Project	<b>IEEE 802.16 Broadband Wireless Access Working Group</b> < <a href="http://ieee802.org/16">http://ieee802.org/16</a> >	
Title	<b>Improvement to clause 15.4.5</b>	
Date Submitted	<b>2008-06-10</b>	
Source(s)	David Grandblaise Motorola Labs Parc Les Algorithmes Commune de Saint Aubin 91193 Gif sur Yvette, France	Voice: +33 (0)1 6935 2582 mailto: <a href="mailto:david.grandblaise@motorola.com">david.grandblaise@motorola.com</a>
Re:	IEEE 80216h-08/026 (recirc LB #29c)	
Abstract	This contribution proposes text improvement for section 15.4.5 on CT-CXP to take into account updates on MAC messages and primitives.	
Purpose	Improve clause 15.4.5 text.	
Notice	<i>This document does not represent the agreed views of the IEEE 802.16 Working Group or any of its subgroups. It represents only the views of the participants listed in the "Source(s)" field above. It is offered as a basis for discussion. It is not binding on the contributor(s), who reserve(s) the right to add, amend or withdraw material contained herein.</i>

## Improvement to clause 15.4.5

This contribution proposes text improvement for section 15.4.5 on CT-CXP to take into account updates on MAC messages and primitives.

Figure h55—Whole CT-CXP Procedure

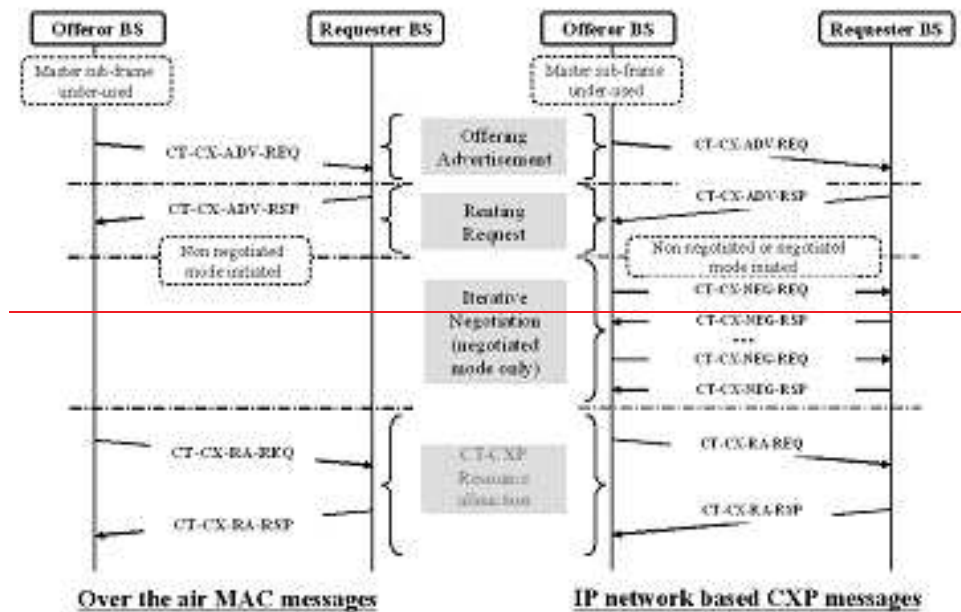
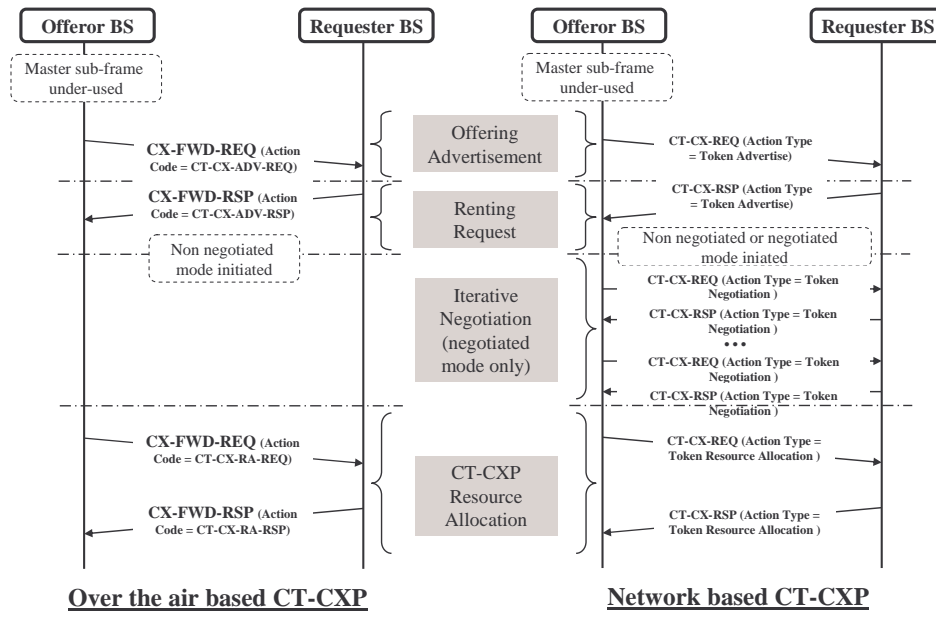
CT-CXP is composed of several consecutive procedures (offering advertisement, renting request, iterative negotiation, and CT-CXP resource allocation) as shown in ~~Whole CT-CXP Procedure~~ [Figure h55](#). For the sake of simplicity, this figure is only depicted for one (among multiple) requesters. Over the air based instantiation of CT-CXP for the non negotiated mode is depicted on the left hand side of

Whole CT-CXP Procedure. The over network based instantiation of CT-CXP for the negotiation or non negotiated mode is depicted on the right hand side of Whole CT-CXP Procedure. Inter system over the air messages are encapsulated within CX-REQ-MAC and CX-RSP-MAC messages (section **Error! Reference source not found.**). Inter system over the air communications mechanisms are described in subclause **Error! Reference source not found.** Primitives related to network based instantiation are specified in section **Error! Reference source not found.** ~~The offering advertisement message (CT-CX-ADV-REQ)~~ The primitive C-CX-REQ (Action Type = Token Advertisement) specifies which negotiation mode is used by the CT-CXP. The iterative negotiation procedure is executed only with the negotiated mode and not with the non-negotiated mode.

Figure h56—Over the air based CT-CXP offering procedure

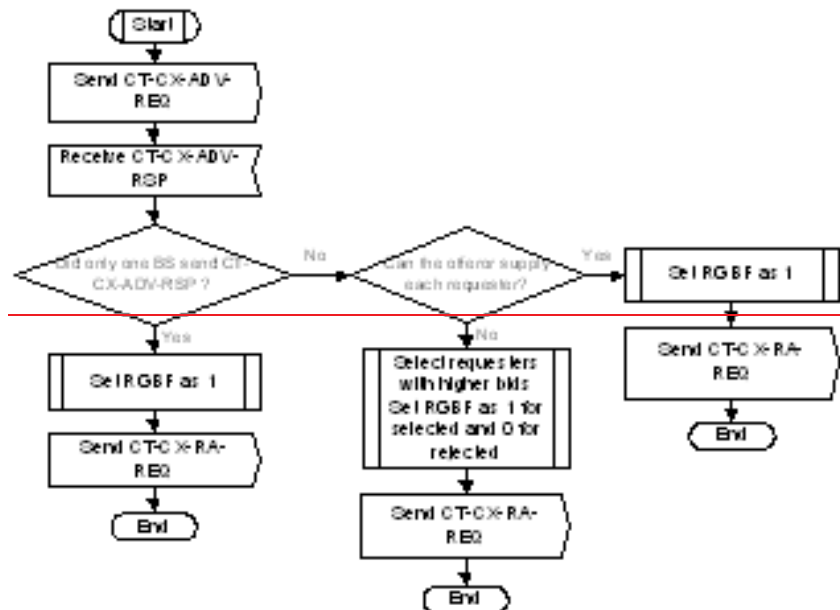
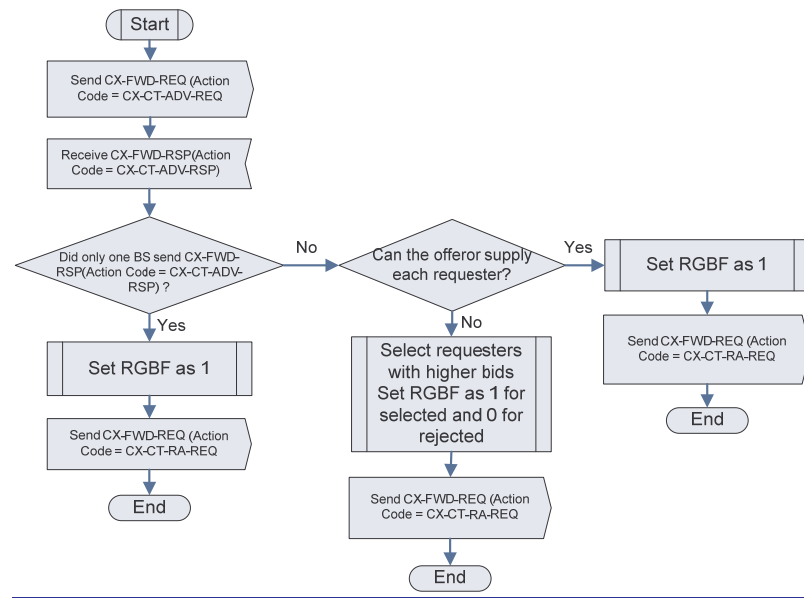
a) The over the air procedure described in ~~Over the air based CT-CXP offering procedure~~ [Figure h56](#) is as follows:

- A BS identifies that a part of its master sub-frame is going to be under-used and can be rented out. With respect to this, this BS becomes an offeror BS and initiates the renting advertisement by broadcasting the ~~CT-CX-ADV-REQ~~ CX-FWD-REQ (Action code = CT-CX-ADV-REQ) message. In particular, this message includes information related to the available resource (T\_renting\_sub-frame, Renting\_out\_start\_time, Renting\_out\_end\_time) as well as the renting conditions (MNCT: Minimum number of credit tokens per RRU required per requester's bid), and also a list (LC: List of Channels) of other channels (frequency domain) proposed by the offeror BS for renting.

- If the offeror BS receives one single ~~CT-CX-ADV-RSP~~ CX-FWD-RSP (Action code = CT-CX-ADV-RSP) message, then the offeror BS grants the renting resource to the single requester by setting the Resource Granting Bit Flag (RGBF) to 1 in ~~the CX-FWD-REQ (Action code = CT-CX-RA-REQ)~~ CT-CX-RA-REQ message. The granted requester is not charged with credit token since it is not competing with some other requesters. The offeror provides to the granted requester with the list of the BSIDs of the systems belonging to the offeror's community. This list is provided within CX-FWD-REQ (Action code = CT-CX-RA-REQ) ~~the CT-CX-RA-REQ message.~~

Figure h57—Network based CT-CXP offering procedure

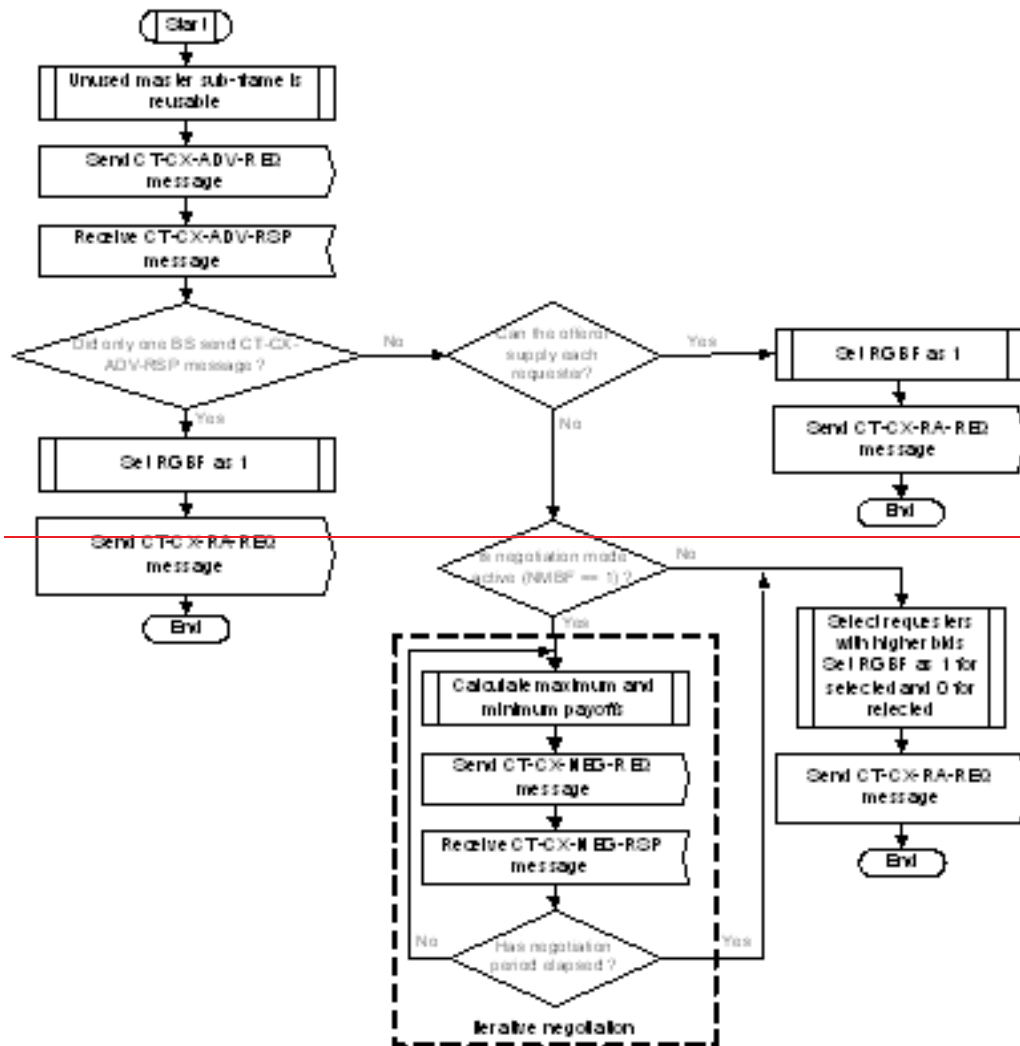
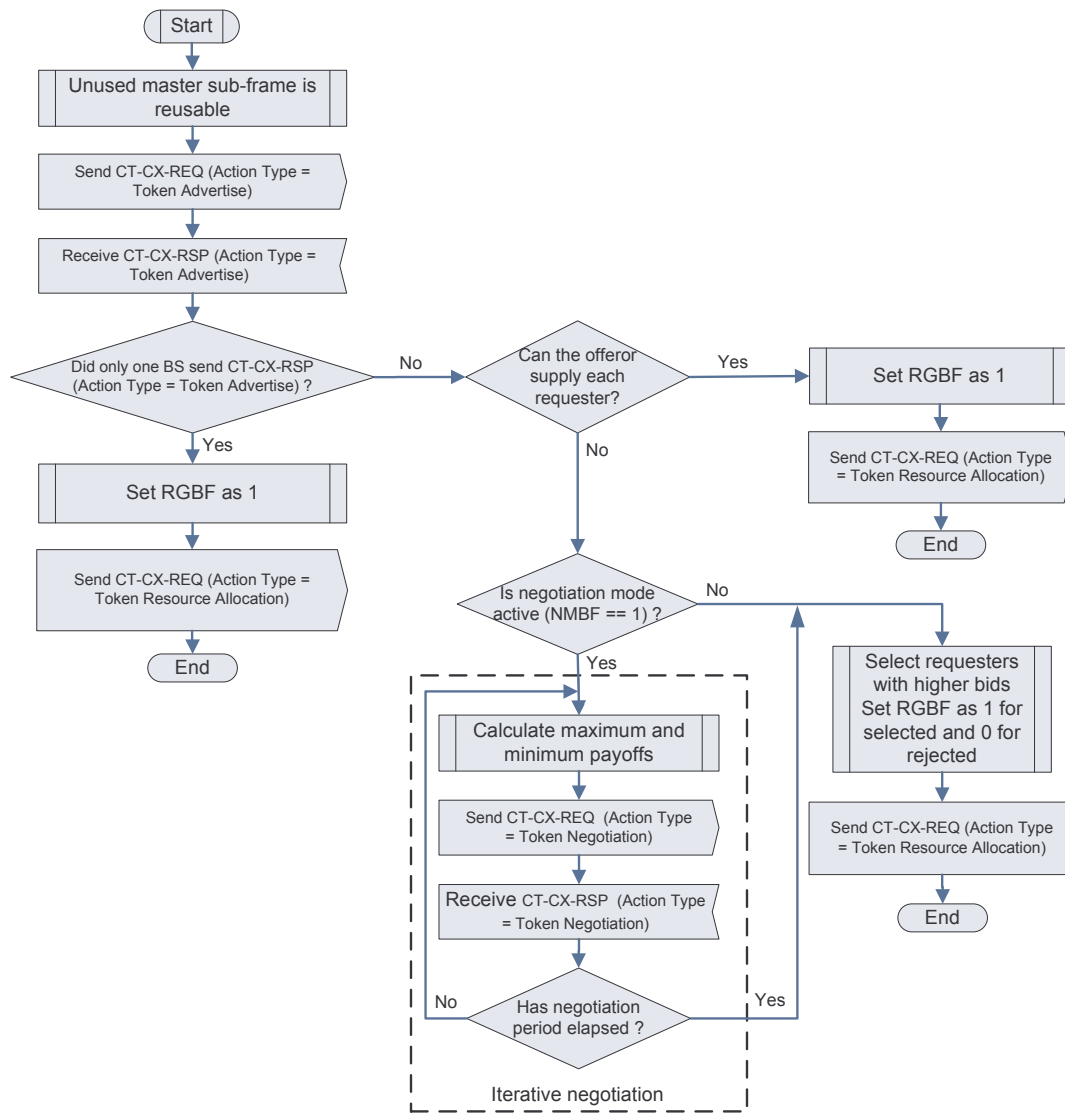
b) The network procedure described in ~~Network based CT-CXP offering procedure~~ [Figure h57](#) is as follows:

- A BS identifies that a part of its master sub-frame is going to be under-used and can be rented out. With respect to this, this BS becomes an offeror BS and initiates the renting advertisement by broadcasting ~~the CT-CX-ADV-REQ message~~ [C-CX-REQ \(Action Type = Token Advertisement\)](#). In particular, this message includes information related to:

- o The renting conditions (Start\_negotiation\_time, End\_negotiation\_time, MNCT, LC)
  - o The pricing method in case NMBF == 1
- If the offeror BS receives one single ~~CT-CX-ADV-RSP message~~ [C-CX-RSP \(Action Type = Token Advertisement\)](#), then the offeror BS grants the renting resource to the single requester by setting the Resource Granting Bit Flag (RGBF) to 1 in ~~the CT-CX-RA-REQ message~~ [C-CX-REQ \(Action Type = Token Resource Allocation\)](#). The granted requester is not charged with credit token since it is not competing with some other requesters. The offeror provides to the granted requester with the list of the BSIDs of the systems belonging to the offeror's community. This list is provided within [C-CX-REQ \(Action Type = Token Resource Allocation\)](#). ~~the CT-CX-RA-REQ message.~~

Figure h58—Over the air based CT-CXP requesting procedure

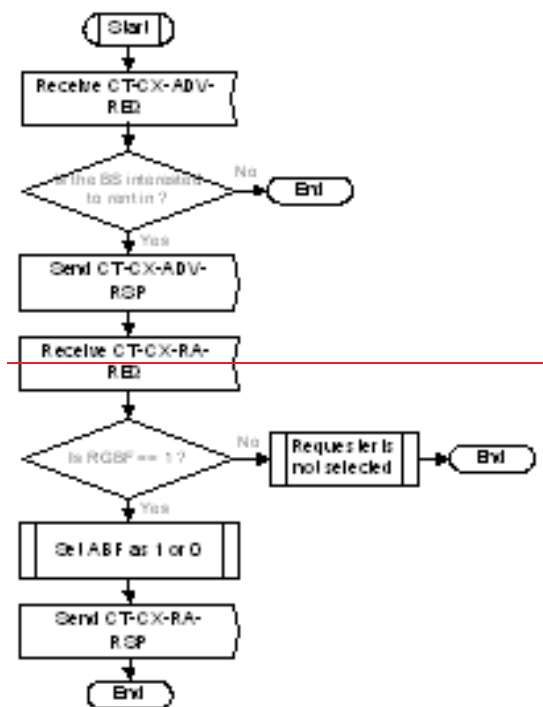
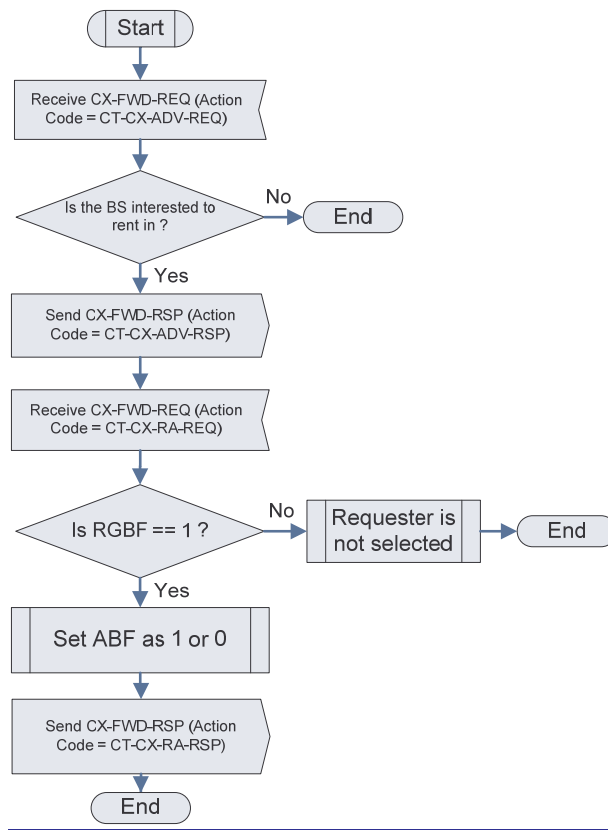
a) The over the air procedure described in ~~Over the air based CT-CXP requesting procedure~~ [Figure h58](#) is as follows:

- If a BS is in need of additional resource and can meet MNCT requirements, he can make a request CX-FWD-RSP (Action code = CT-CX-ADV-RSP) ~~(CT-CX-ADV-RSP message)~~ upon the reception of CX-FWD-REQ (Action code = CT-CX-ADV-REQ) ~~CT-CX-ADV-REQ~~.
- Within CX-FWD-RSP (Action code = CT-CX-ADV-RSP) ~~CT-CX-ADV-RSP~~, the requester informs about the amount of required resource (Rented\_resoure\_amount), the rented in start

- Upon reception of CX-FWD-REQ (Action code = CT-CX-RA-RSP)~~CT-CX-RA-REQ message~~, the requester BS knows whether it has been selected or not. If RGBF is set to 1, the requester BS is selected, otherwise (RGBF set to 0) the requester is rejected.

Figure h59—Network based CT-CXP requesting procedure

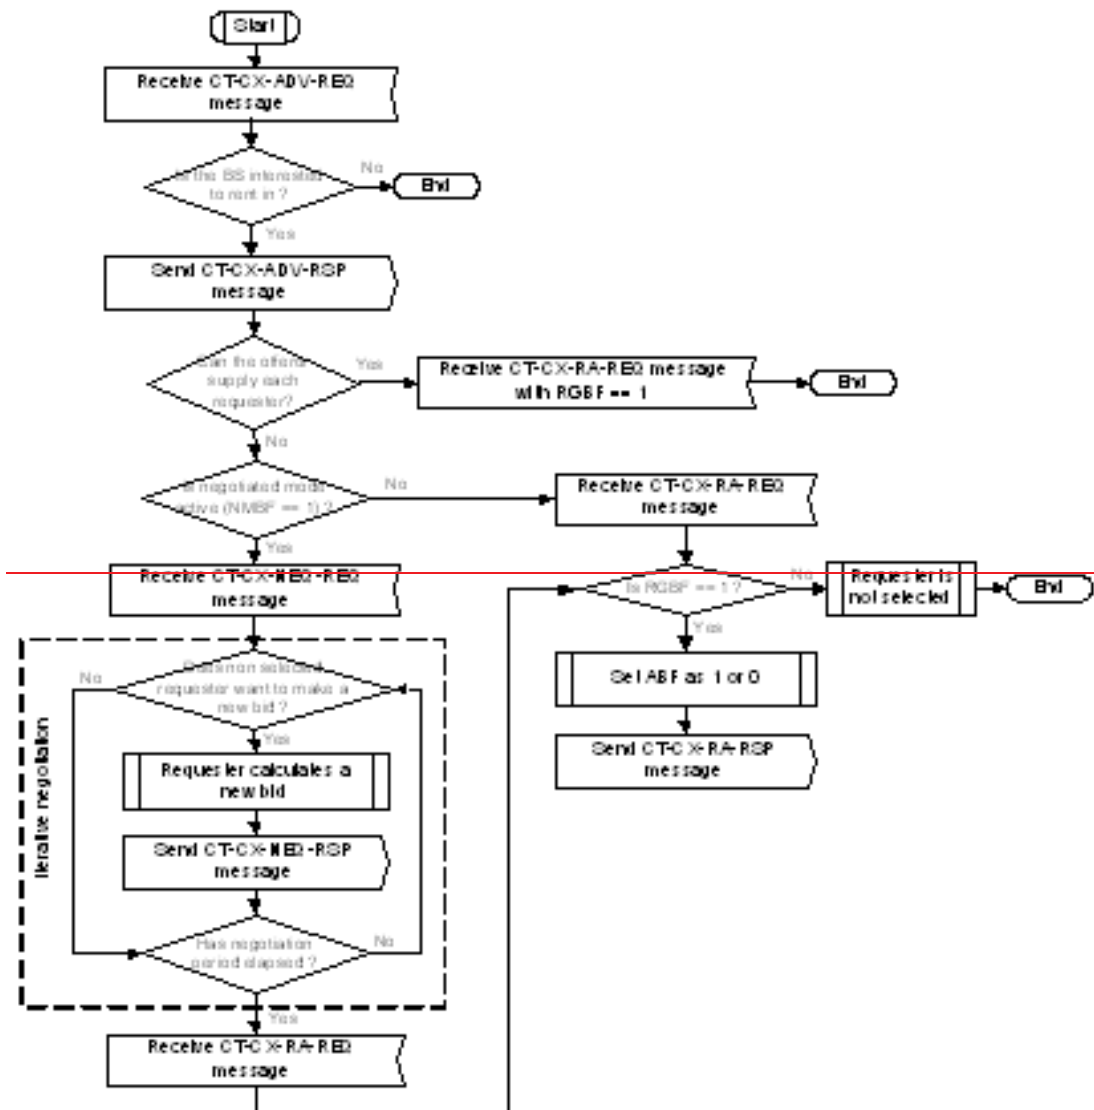
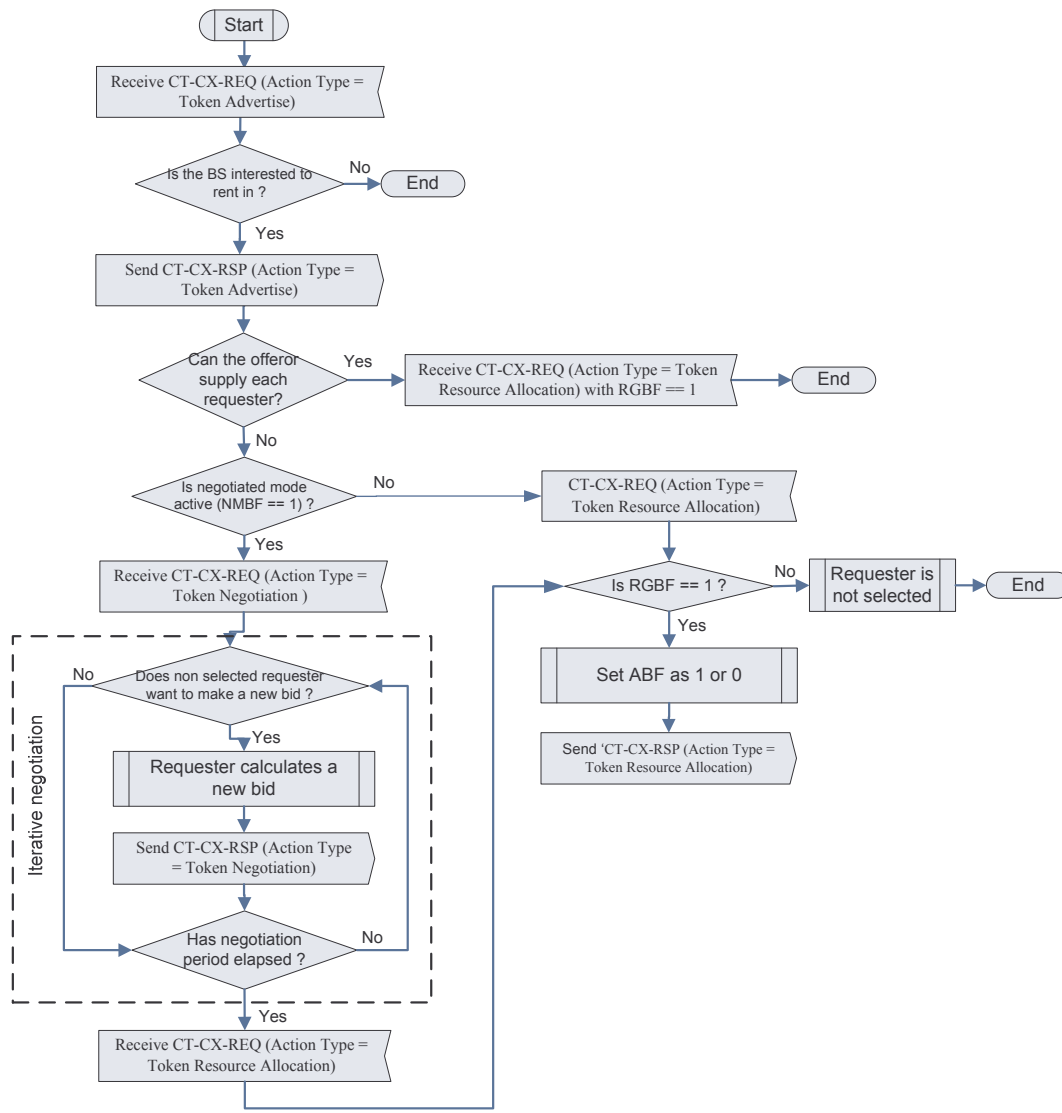
b) The network procedure described in ~~network based CT-CXP requesting procedure~~ [Figure h59](#) is as follows:

- If a BS is in need of additional resource, meets MNCT requirements, and agrees with the proposed negotiation mode (NMBF) and pricing method (PBF) specified within C-CX-REQ (Action Type = Token Advertisement), ~~the CT-CX-ADV-REQ message~~, he can submit a bid (within C-CX-RSP (Action Type = Token Advertisement), ~~CT-CX-ADV-RSP message~~) upon the reception of the C-CX-REQ (Action Type = Token Advertisement). ~~CT-CX-ADV-REQ message~~.

- o If the negotiation mode is active (NMBF == 1), iterative negotiation occurs between the offeror BS and each requester BS. At each iteration, based on the information Minimum\_payoff and Maximal\_payoff received from ~~the CT-CX-NEG-REQ message~~ C-CX-REQ (Action Type = Token Negotiation), the requester decides to submit a new bid (Requester\_bid\_update) or not. Requester\_bid\_update is sent within C-CX-RSP
